# MANN-FILTER

No 175  
21/07/2022

### Cabin air filter with plastic insert and cover: new solution for various Mercedes-Benz models

**Image 1:** The cabin air filters from MANN-FILTER have a black plastic insert and an integrated cover, so no pins do ingress.

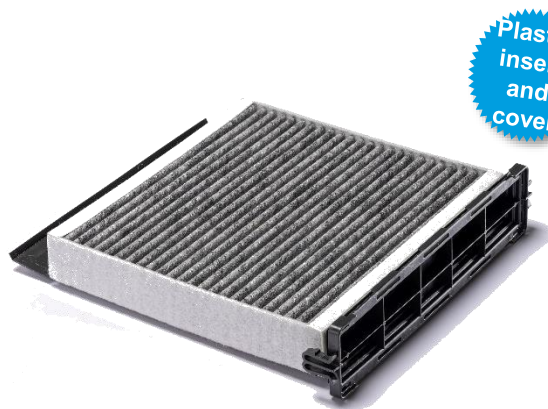
The black plastic insert and the subsequently less number of pleats are evident, just as the integrated cover (image 1).

The original filter has two holes on both sides (image 2). Pins inside both the housing and the original cover are received by the respective holes of the element. This combination is patented.

**Image 2:** The OE filters have two holes on both sides and a separate cover. Two pins placed in the housing can ingress in the filter as well as the pins on the cover.

The original cover (order no.: 247 830 85 00) is no longer needed.
